ENGINEERING CHANGE REQUEST (ECR)

CUSTOMER DRAWING NO. D972118

DRAWING TITLE L190 BSC CROSSBEAM WELDMENT

REVISION: FROM C TO D

HYTEC, INC	
LIGO SSC	
CROSSEAM WELDMENT	
PART NO. 0972118-1	0972118 D 1 of 1

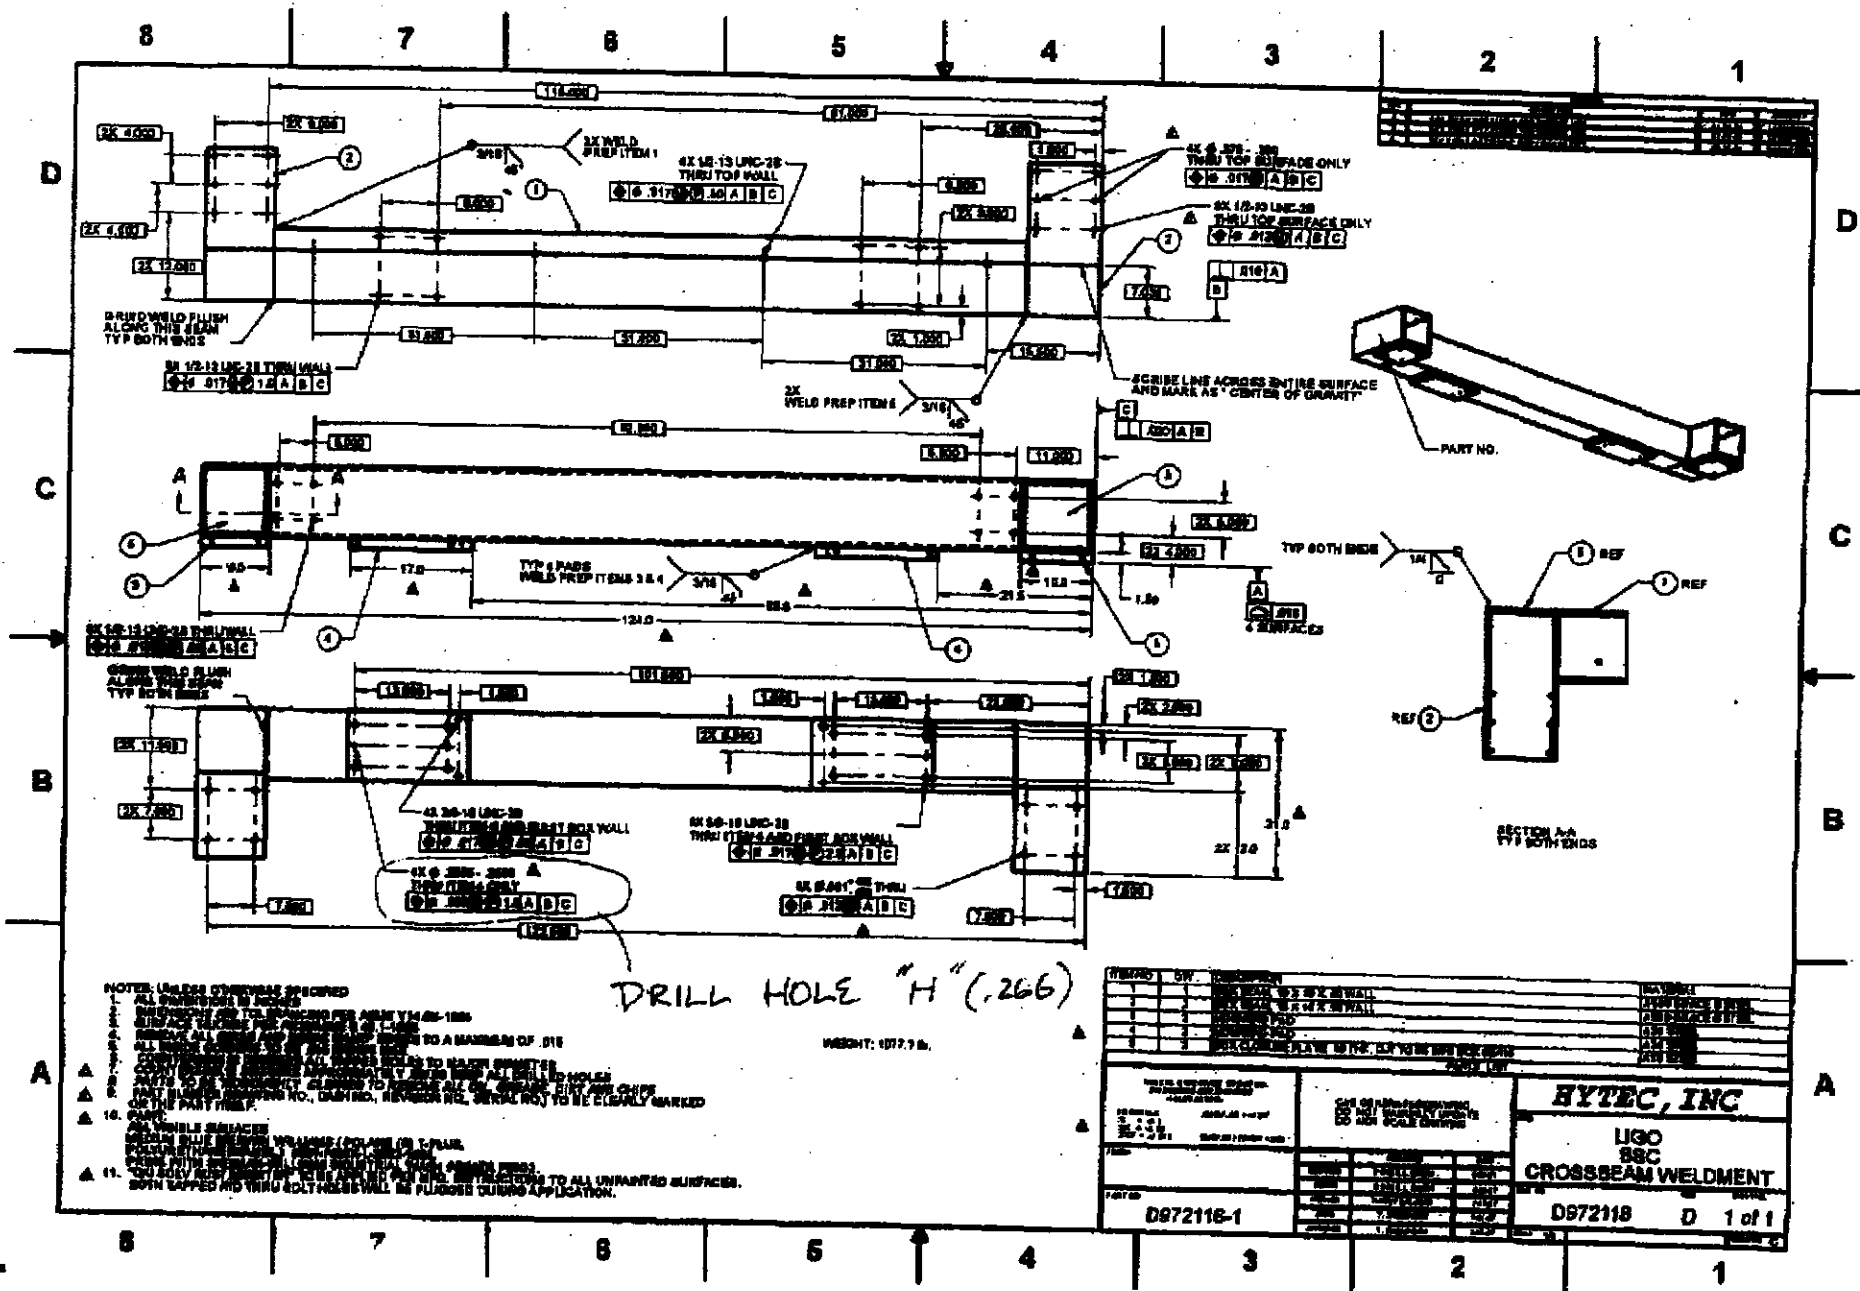
CHANGE AX Ø .2505 - .2509 THEN ITEM 4 ONLY
TO DRILL SIZE H (.266) HOLE

.2509 HOLES LOOSENED TO MATCH PINS IN
CENTERING JIG
